October 11, 2021
Product Department Bulletin
INFORMATION: PRODUCT CHANGE - RG275H & LG275H Improvements

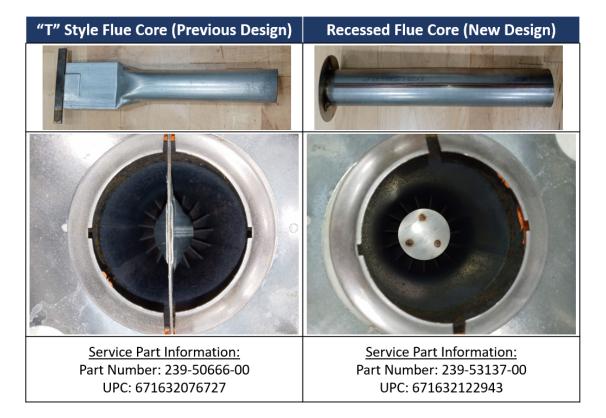
The traditional "T" style flue core has been replaced with a more robust recessed flue core that rests inside the flue versus on top of the flue reducer. The recessed flue core creates a more efficient and quieter product. Please note that a flue reducer is used in both designs.

This change went into effect on $\underline{6/2/2021}$ on the RG275H & LG275H with serial numbers starting with characters $\underline{\mathbf{XF}}$. Please note that the new design is not backwards compatible and service parts should be ordered based on serial number/manufacture date.
